I refer to your request, received on 17 March 2022, for the following information under the Official Information Act 1982 (the Act):

- Any correspondence including confirmation of decisions and outcomes regarding the audit dispute referred to in your letter of 17 March 2022 to the Electricity Authority Compliance Committee.

From: s9(2)(a)
Sent: Wednesday, 13 March 2019 3:46 pm
To: Alex Ehler; Ron Beatty
Cc: s9(2)(a)
Subject: Authority Meeting 25/2/2019
Attachments: LMGL DELTA Paper Stat Sample Mar 2019.docx

ELECTRICITY INDUSTRY PARTICIPATION CODE
METERING EQUIPMENT PROVIDER AUDIT REPORT

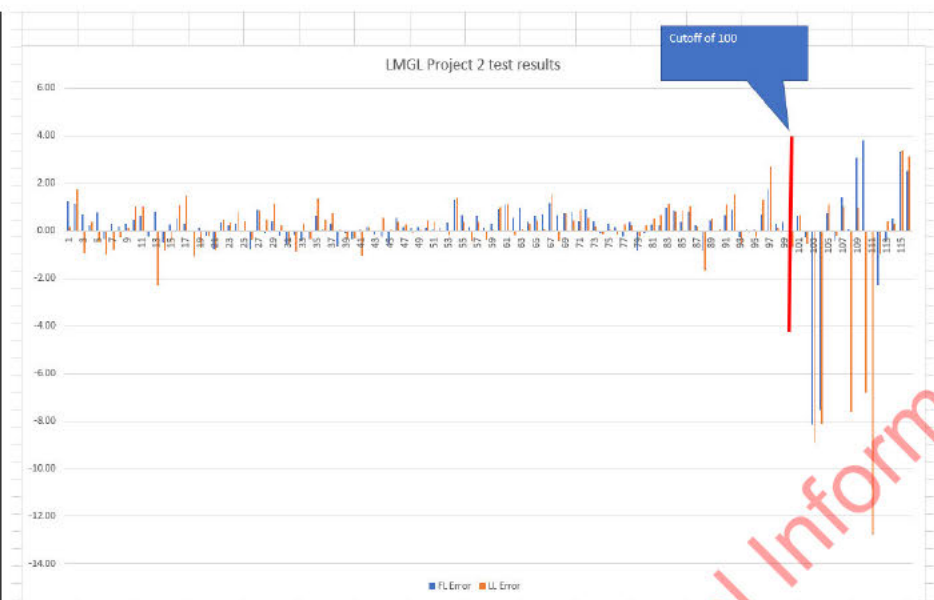
The graph below shows that the "cutoff" point of 100 excludes a high proportion of inaccurate meters. Clause 8.4 of AS/NZS 1284.13 requires the sample to be *"randomly selected to be representative of the selected meter population."* The graph below shows that the sample is not representative of the meter population.

An additional point to note is that the "order" of 1 to 116 is not a randomly selected order, it is the order that meters were tested. It appears that the first 80 meters tested were Sangamo S200 and the next 20 were Iskra E89. It appears that the remaining 16 meters (not considered in the results) were from seven different makes/models, including two three phase meters. This means only two of nine meter types were considered in the pass/fail calculation, there were two three phase meters amongst the 16 not tested. The two three phase meters both had errors over 3% at the 0.5 power factor test point which could mean the entire population fails just on that issue. The standard states that all test points have equal weight, therefore the 0.5 power factor test point must be considered. The extract from the standard is shown below.

Also, suggesting that the failures found in the next 16 have relevance is a large assumption as this regression to mean suggestion on such a limited number does not hold weight in Statistics. That is, the rate of failure of a sequence does not suggest that more results of the same kind will occur at all or to the same percentage of finding rate. This point is especially pertinent in the eyes of the Test Lab and Test House who considered both the meters in question, their results and the nature of the population concerned that they related to.
